**BEFORE THE BOARD OF PATENT APPEALS
AND INTERFERENCES**

Application Number: 10/718,086
Filing Date: November 19, 2003
Appellant(s): CLEMENS, READE

EXAMINER'S ANSWER

FIG. 2

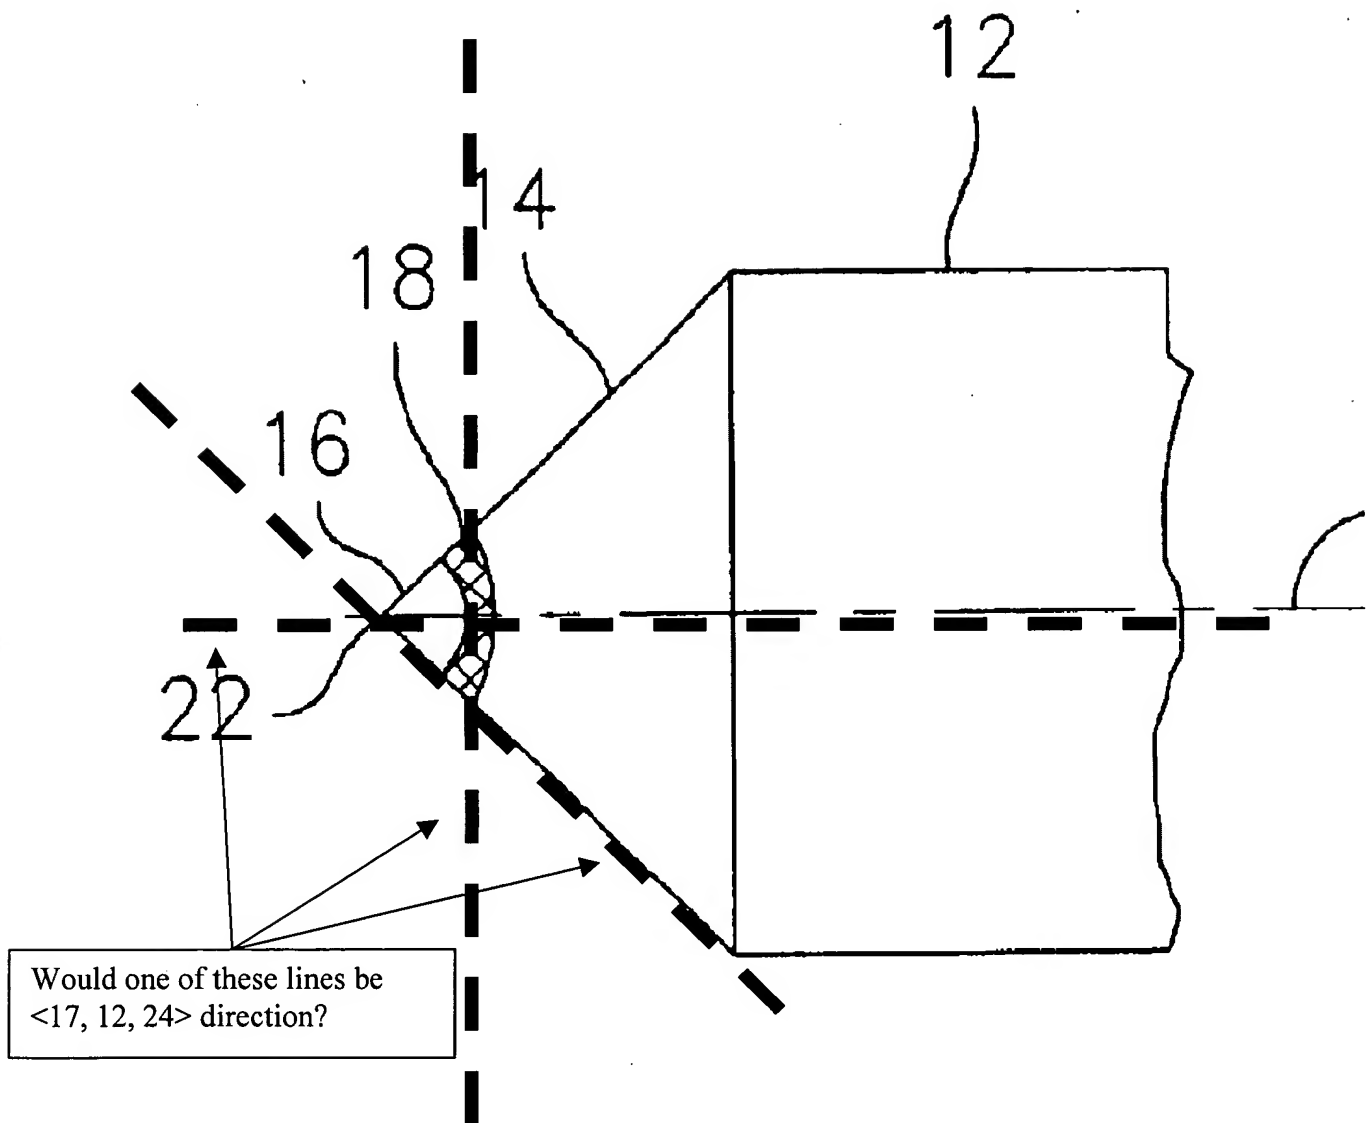
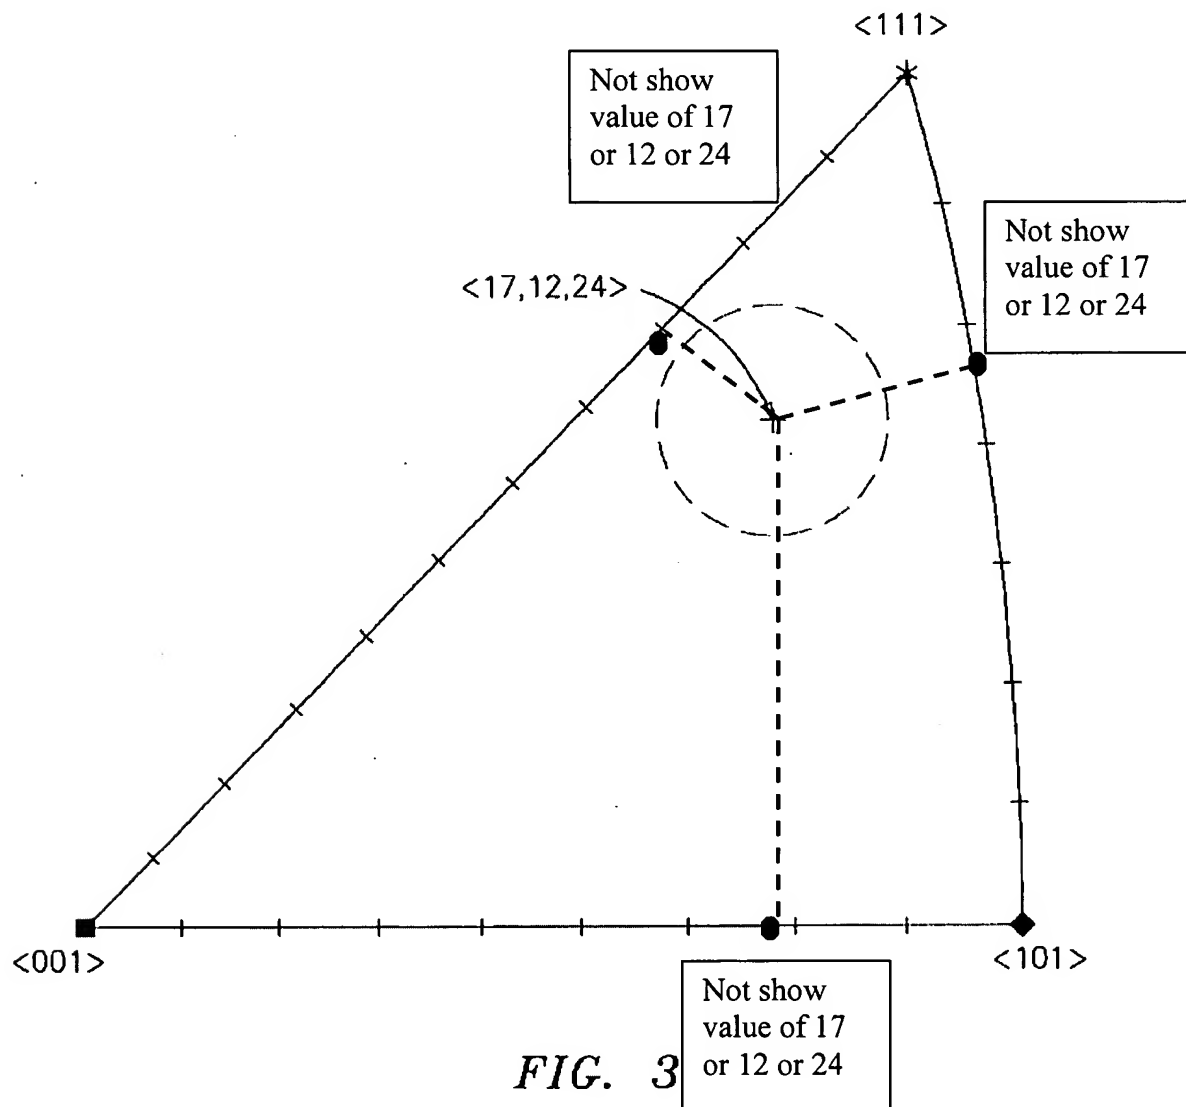
The Applicant does not provide enough information of the <17, 12, 24> direction so that one of ordinary skill in the art can make and use the claimed invention. For example, would the

cutting tip 22 in Fig. 1 of the disclosure not be tilted more than 8 degrees with respect to the shank axis 24 is what the Applicant claims? Or would one of the surfaces of the indenting tip be <17, 12, 24> direction? See below sketch.

The Applicant asserts that Fig. 3 represents the $\langle 17, 12, 24 \rangle$ direction. However, projecting perpendicular lines from the coordinate $\langle 17, 12, 24 \rangle$ does not produce the same value of the coordinate. See below sketch.

FIG. 8

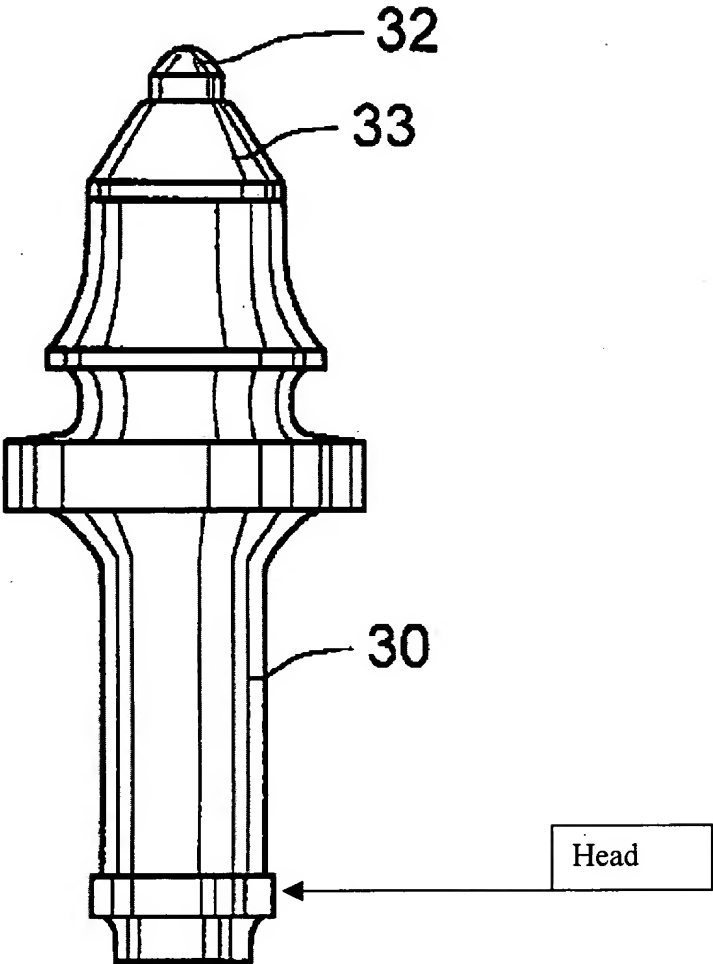
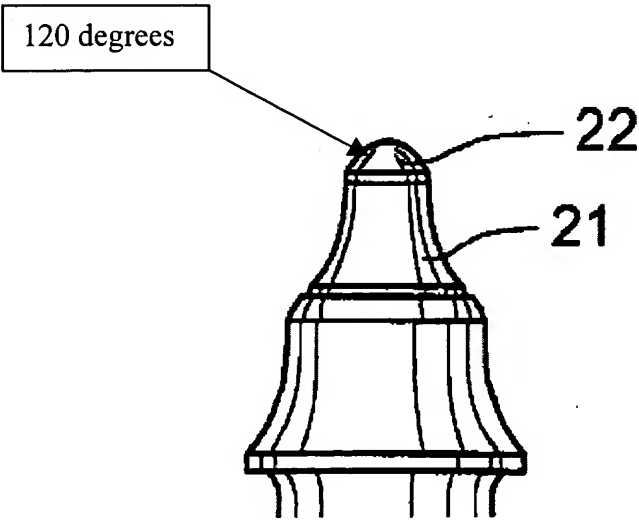
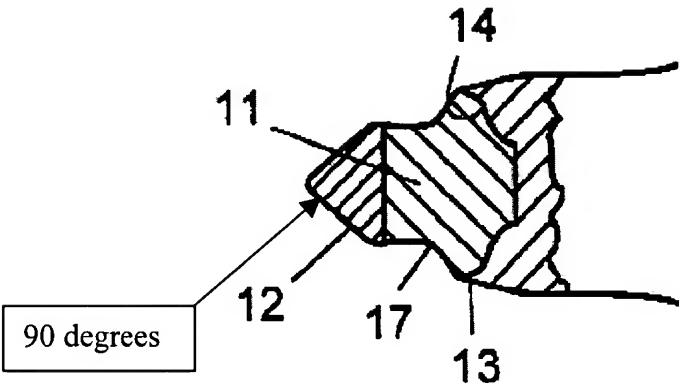
The Applicant argues that Anderson does not teach forming a shank to which a diamond is attached from steel (claim 2); a head formed adjacent a second end of the shank (claim 3); a head which is wider than the shank (claim 4); the use of a single crystal diamond (claims 5 and 6); a diamond which in a final ground state has a length greater than an indentation depth to be imparted to a part to be marked (claim 8); a diamond having a 90 degree included angle conical point (see Fig. 7); a diamond having a 120 degree included angle conical point (see Fig. 5); a brazing alloy which wets both the diamond and the material forming the shank (claim 11); and a shank with a tapered tip end (claim 12) to which a diamond is attached. This argument is not persuasive.

Anderson teaches forming a shank to which a diamond is attached from steel (col. 5, lines 5-10); a head formed adjacent a second end of the shank (see Fig. 8); a head which is wider than the shank (see Fig. 8); the use of a single crystal diamond (there is one indenting tip and it is covered by diamond coating; therefore the indenting tip is a single diamond); a diamond which in a final ground state has a length greater than an indentation depth to be imparted to a part to be marked (it is inherent.); a diamond having a 90 degree included angle conical point (see Fig. 3); a diamond having a 120 degree included angle conical point (claim 10); a brazing alloy which wets both the diamond and the material forming the shank (see the Abstract and col. 3, lines 29-54); and a shank with a tapered tip end 12 (see Fig. 3) to which a diamond is attached.
